# Access Compliance Report

## Public Rights-of-Way

### (Curb Ramps)

Intersection ID: 50494	Main Street: BLAIREBETH_ST	Cross Street: HAWFIELD_WAY_DR	Location: SW
ADA ID: DE6CD2778A1A	Ramp Type: PerpDiag	Initial Pass/Fail: Fail	Overall Compliance: No
		Severity Score: 1.25

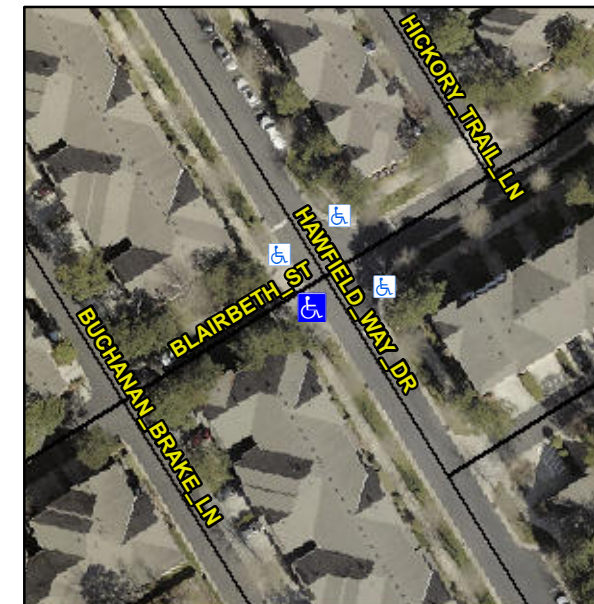
**R304.5.3**

Compliance	Description	Data	Compliance	Description	Data
N/A	Ramp Length (in)	79.0	Yes	Ramp Slope (%)	5.5
Yes	Ramp Width (in)	48.0	No	Ramp XSlope (%)	4.5
N/A	Flare Type LT	N/A	N/A	Flare Type RT	N/A
N/A	Flare Slope LT (%)	N/A	N/A	Flare Slope RT (%)	N/A
N/A	Flare Traversable LT?	N/A	N/A	Flare Traversable RT?	N/A
N/A	Landing Length (in)	N/A	N/A	DWS Provided?	N/A
N/A	Landing Width (in)	N/A	N/A	DWS Contrast?	N/A
N/A	Landing Slope (%)	N/A	N/A	DWS Length (in)	N/A
N/A	Landing X Slope (%)	N/A	N/A	DWS Full Width?	N/A
N/A	Landing Curb? (Y/N)	N/A	N/A	DWS Offset (in)	N/A
N/A	Shared Landing?	N/A			
N/A	Gutter Ponding?	N/A	N/A	Gutter Slope (%)	N/A
N/A	Gutter Lip Ht (in)	N/A	N/A	Gutter X Slope (%)	N/A
N/A	Painted X Walk1?	No	N/A	Painted X Walk2?	No
	X Walk 1 Direction	To NE		X Walk 2 Direction	To NW
N/A	X Walk 1 Width (in)	N/A	N/A	X Walk 2 Width (in)	N/A
	X Walk 1 Slope (%)	2.6		X Walk 2 Slope (%)	1.5
	X Walk 1 X Slope (%)	0.9		X Walk 2 X Slope (%)	2.3

**Remove & Replace Curb Ramp With Two New Directional Ramps or Equivalent.**
